**Office Addition  
Little Egg Harbor Municipal Utilities  
823 Radio Road, Little Egg Harbor, N.J.  
Addendum # 1  
May 11, 2026**

**Bid Package Clarification and Changes**

This Addendum dated May 11, 2026, for the Office Addition of Little Egg Harbor Municipal Utilities shall be included as part of the Contract Bid Documents. This Addendum shall supplement and clarify the current Contract Bid Documents.

E-1

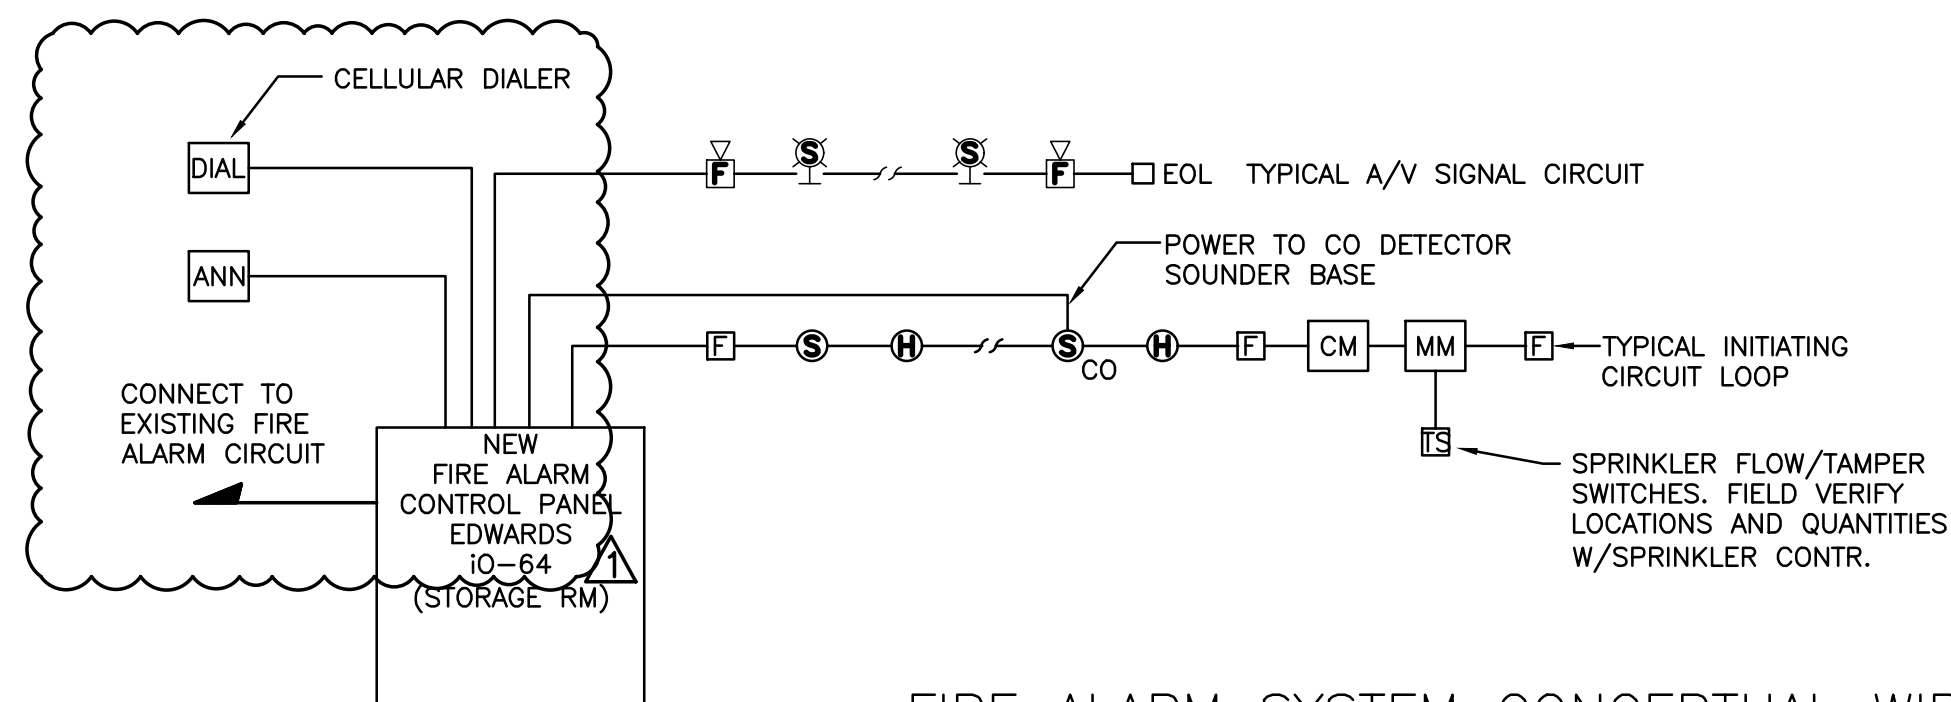
**26. Fire Alarm Control Panel**- Add Cellular Dialer. See Sheet E-01

E-3

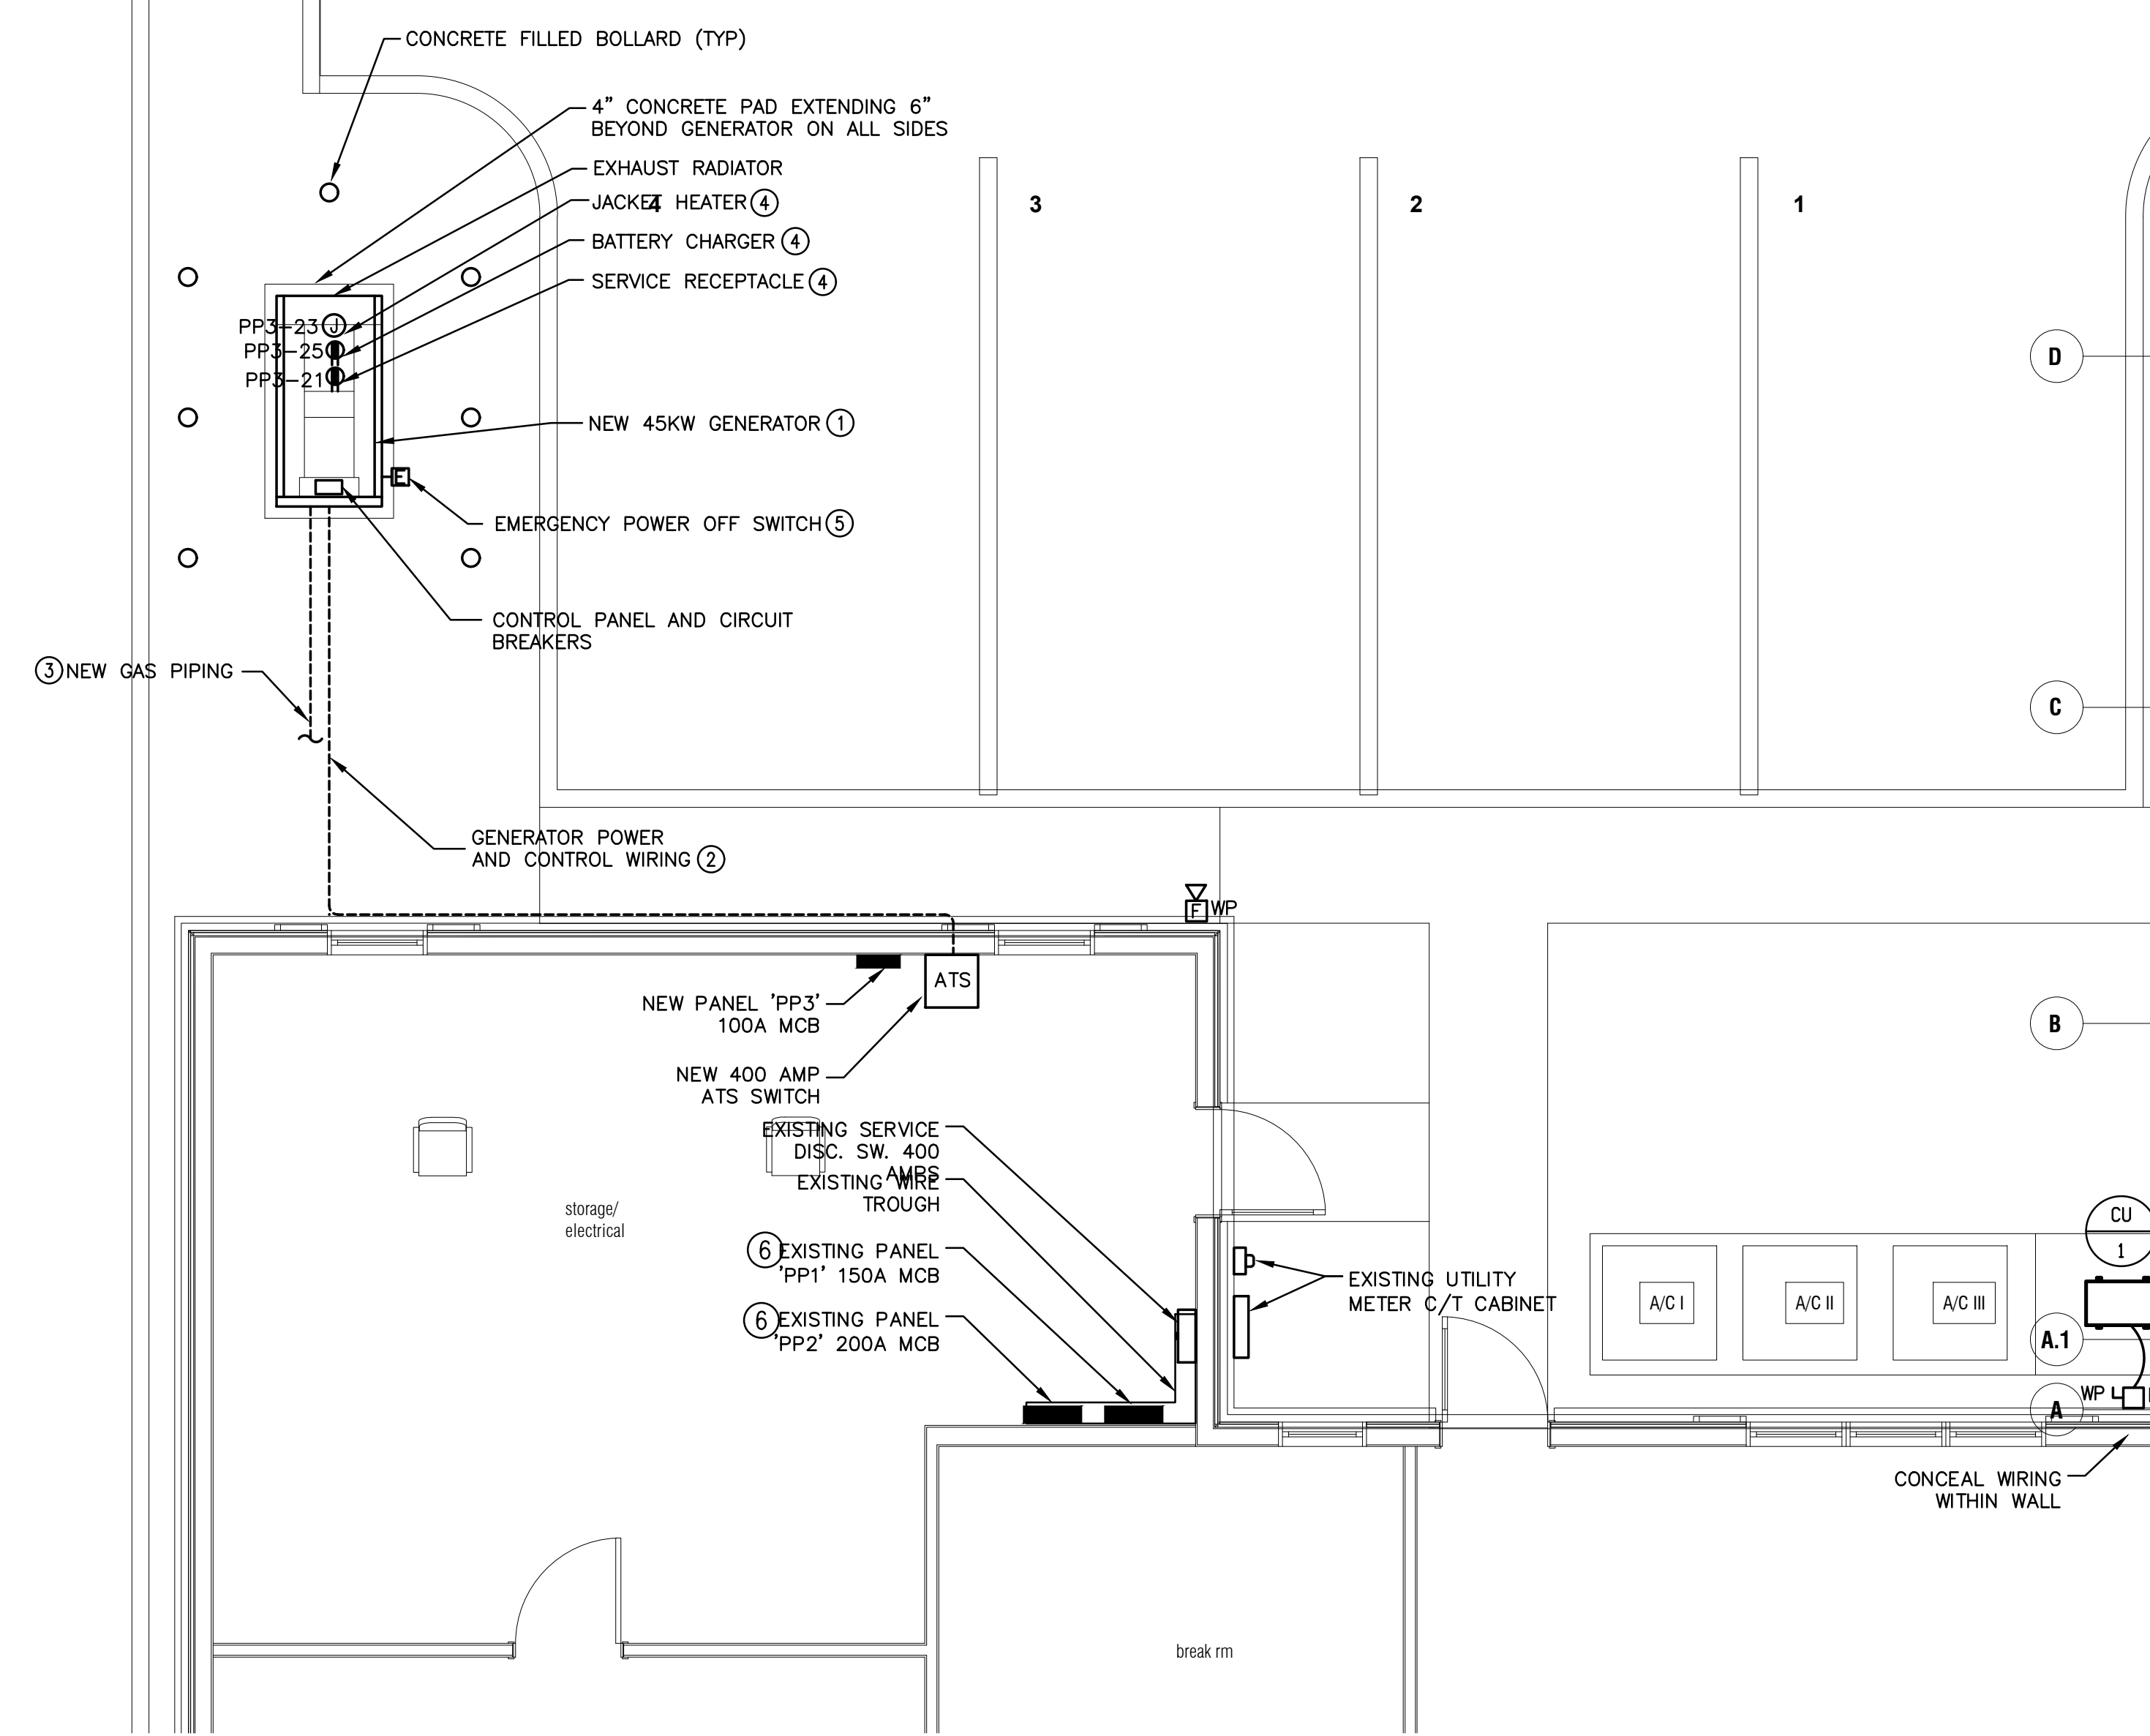
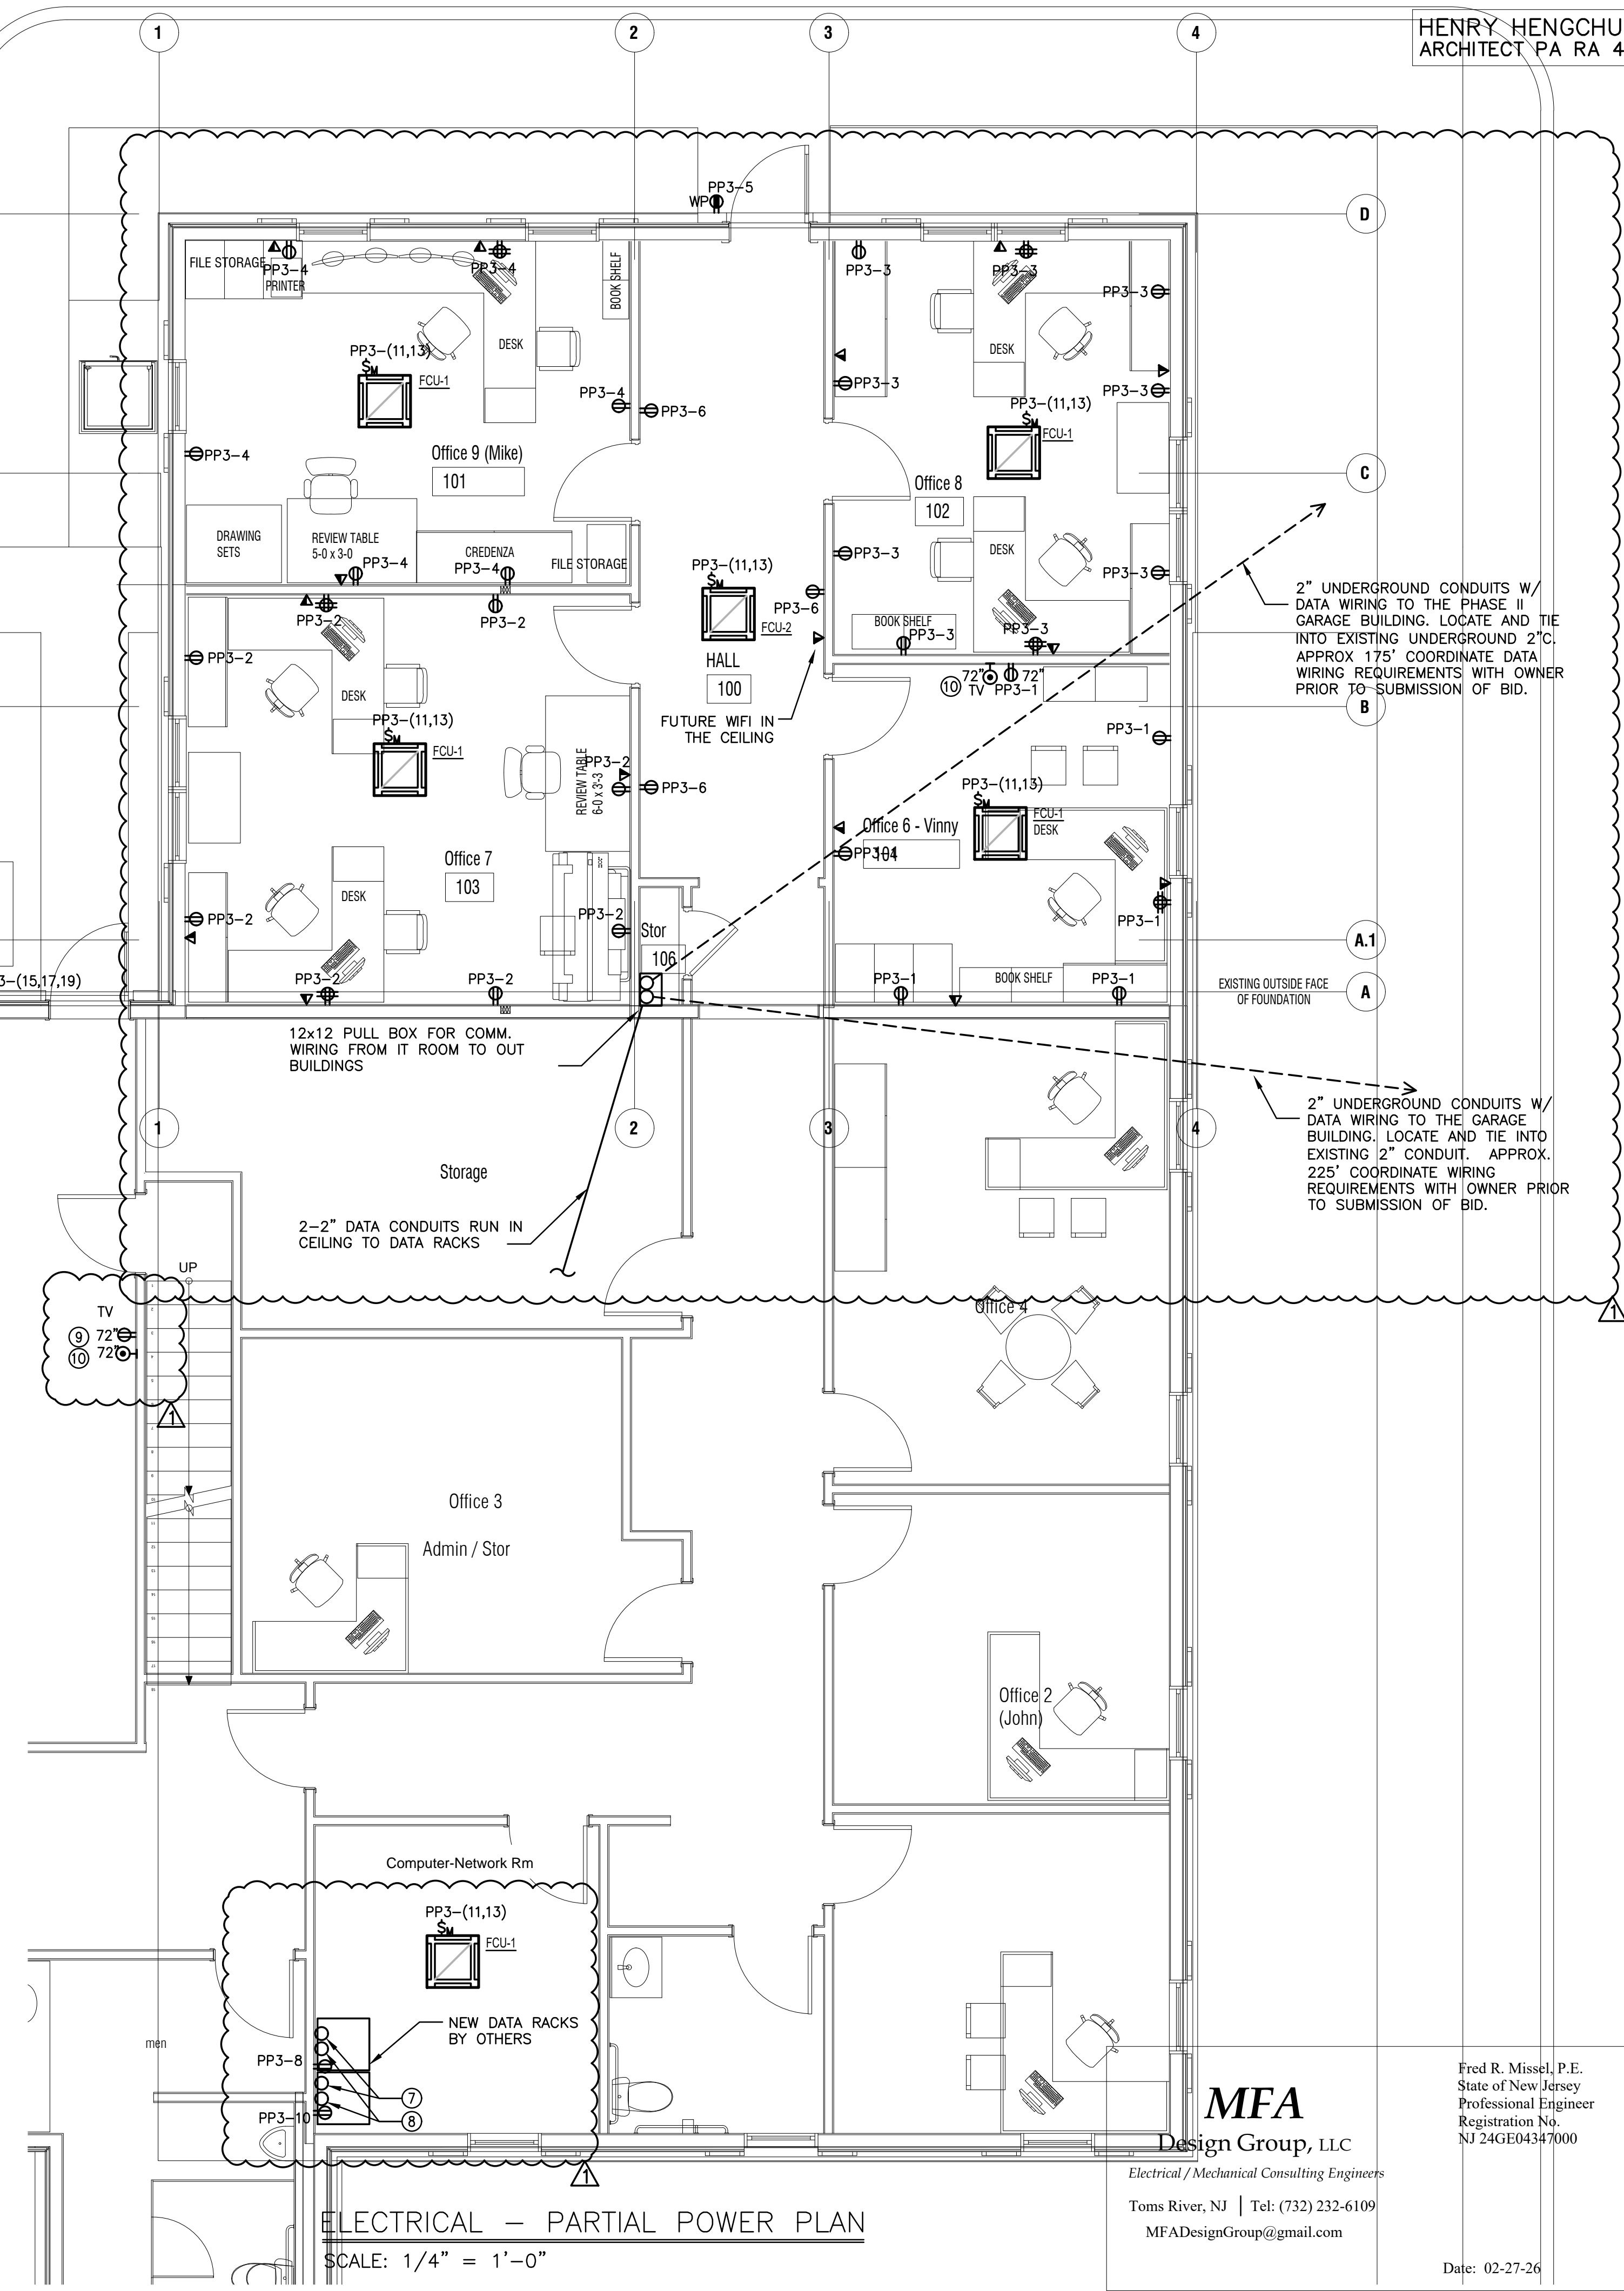
**24. New Office Addition Voice and Data Wall Plates**-Provide 4 port data wall plate and ethernet cables with home runs to Network Room as shown on Sheet E-03, E-06 revised drawing. Coordinate final location of Voice and Data wall plates with owner

Provide a separate Coax cable connection to TV outlet and a single ethernet data outlet for the TV port location. See E-01, E-3 revised drawing. Coordinate final location of Voice and Data wall plates with owner
